GOVERNMENT OF THE DISTRICT OF COLUMBIA
DEPARTMENT OF TRANSPORTATION

MEMORANDUM

SUBJECT: DDOT Report for BZA Case #18544, 1550 Pennsylvania Avenue SE

Figure 1: Proposed Site Layout and Access.

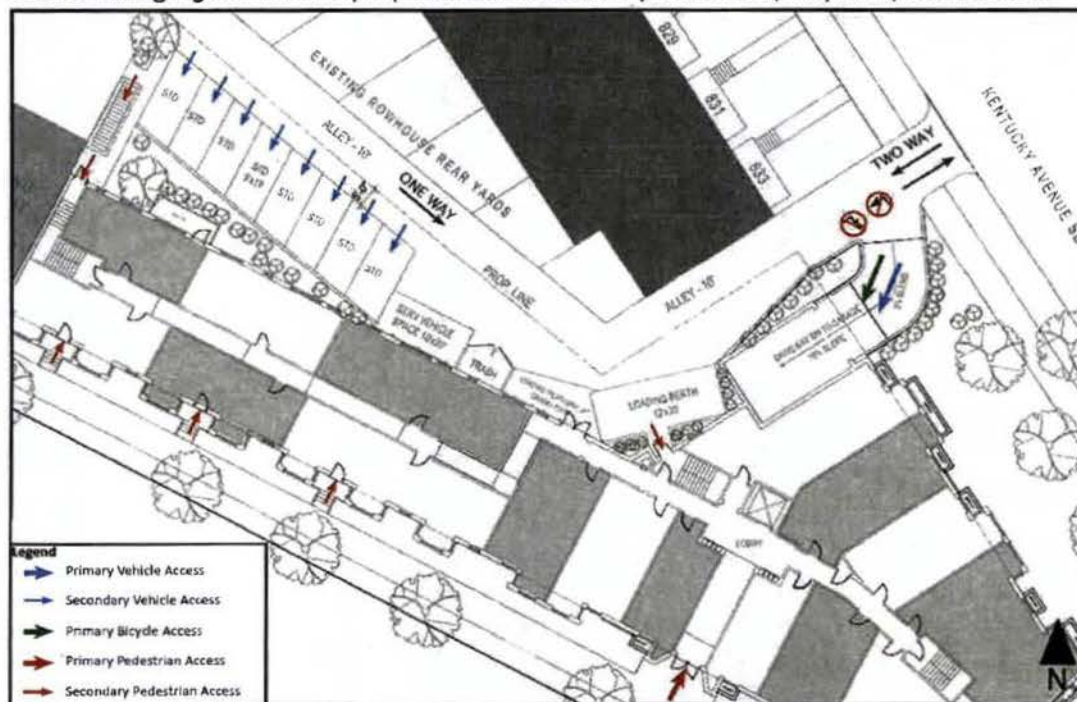
The Applicant proposes to close/abandon the existing curb cuts, two along Kentucky Avenue and two along Pennsylvania Avenue, widen the alley (Freedom Way), and convert it to two-way operation between the garage ramp and Kentucky Avenue. DDOT has significant concerns about the proposed garage ramp's impact on public space. The current proposal calls for a ramp to the garage through public space, which is contrary to DDOT's public space standards. Adding to DDOT's concern is the steep slope (18%) and sharp blend (9%) of the ramp, which DDOT believes creates a safety issue for pedestrians. Finally, the proposed access ramp intersects with Freedom Alley right at the sidewalk along Kentucky Avenue, thus creating a potential conflict point between pedestrians and motorists. In light of these concerns, DDOT will be unlikely to permit the garage access as proposed.

Although DDOT will address permitting concerns after the Board of Zoning Adjustment ruling on the variance requests, the garage access design must be addressed prior to the BZA ruling because DDOT does not believe the Applicant can provide the proposed number of parking spaces and loading configuration while simultaneously complying with DDOT's public space standards. A reconfigured garage access design that can meet DDOT's standards may result in the elimination of several parking spaces and/or a reconfigured loading scheme, both of which would impact the magnitude of the parking and/or loading variance(s) the Applicant is seeking. Given the existing usage of on-street parking, DDOT would support additional on-site parking reduction of up to 5 spaces to address this issue.

- The Applicant should redesign the parking garage access such that public space on Kentucky Avenue is not utilized.
- The Applicant should demonstrate the loading berth adequately accommodates a regulation 30-foot truck.
- The Applicant should increase the number of bicycle parking spaces from 28 to at least 41 to reflect a ratio of one long-term bike parking spaces per every two units, and provide four (4) inverted U-racks for short term public bike parking on the sidewalk in a location approved by DDOT.
- As part of the TDM plan, the Applicant should offer a financial incentive to all new tenants instead of the initial occupants and limit the incentive to Capital Bikeshare membership or a subsidy to a car sharing service.
